# Rezoning Transportation Analysis

Petition Number: 2017-205

**From:** Felix Obregon, PE  
[fobregon@charlottenc.gov](mailto:fobregon@charlottenc.gov)  
704-432-5729

Date	Description
01-19-18	First Review
02-19-18	Second Review
03-22-18	Third Review
10-04-2018	Fourth Review

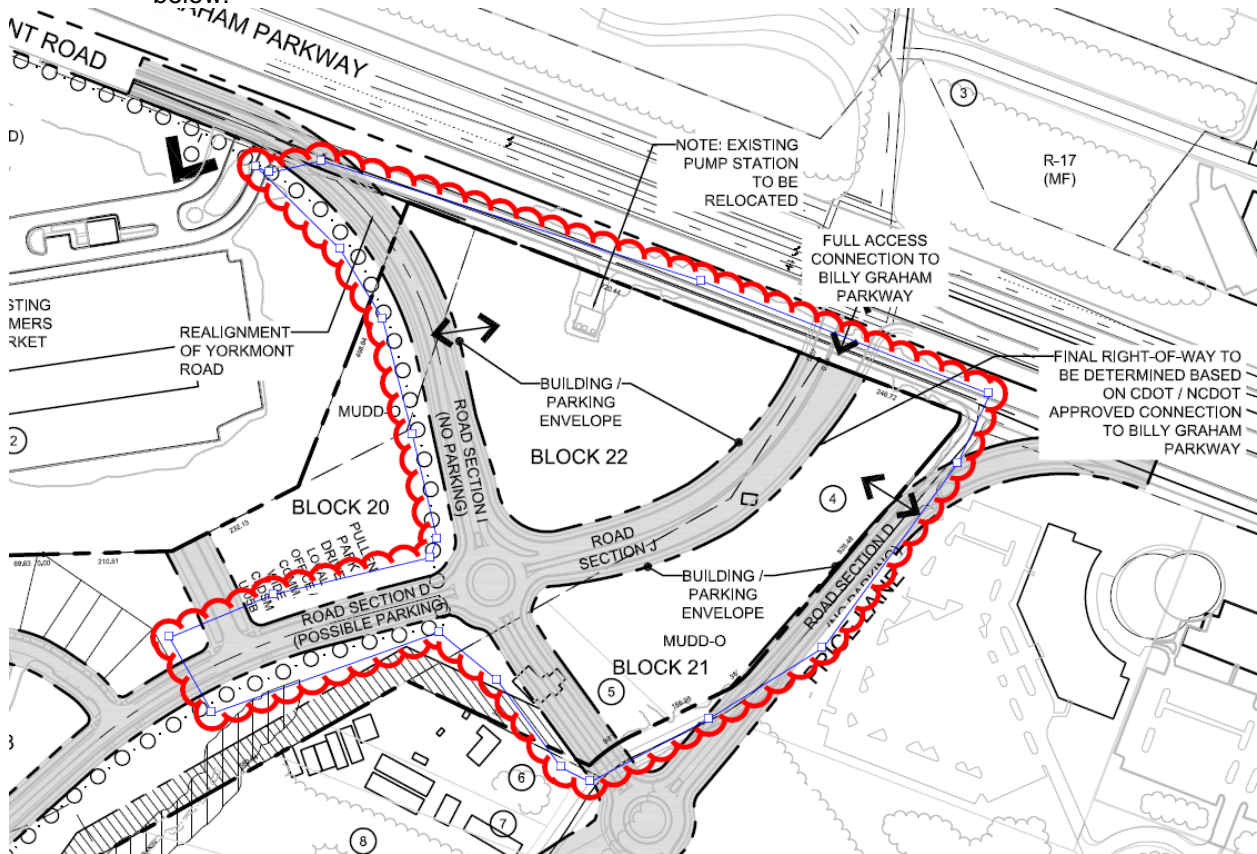
2. **Traffic Study** A Traffic Impact Study/Transportation Technical Memorandum may be needed for the complete review of this petition. CDOT is currently working with the Petitioner in evaluating the required traffic mitigations from Rezoning 2007-082 that have not been built yet and how the proposed rezoning petition affects them. CDOT will have further comments once more information is gathered.

After evaluating the changes proposed in this site plan amendment and the effect it has on existing and future transportation infrastructure, CDOT requests the petitioner revise the site plan to commit to the following before the next request for certificate of occupancy:

- a. the construction of Hive Dr connecting to City Park Dr and Millennium Av as part of the townhome development proposed in the site plan amendment.
- b. dedication of right of way, fee simple, for the future connection of Speer Blvd to Billy Graham Pkwy, the realignment of Yorkmont Rd to connect to the future Speer Blvd and Price Ln as part of the townhome development proposed in the site plan amendment. The right of way location should be shown on the plan as depicted in the approved 2007-082 rezoning shown below:

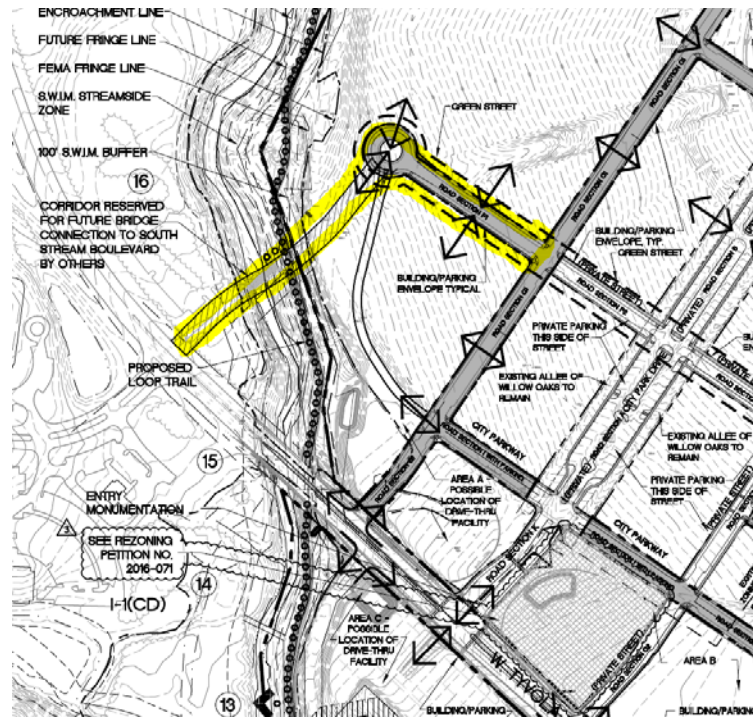
3. **COMMENT RESCINDED** - The petitioner should revise the site plan and conditional note(s) to show the street network connection approved in rezoning 2007-082 and the dedication of right of way for future bridge connection to Tyvela Rd, also part of the 2007-082 approved rezoning.
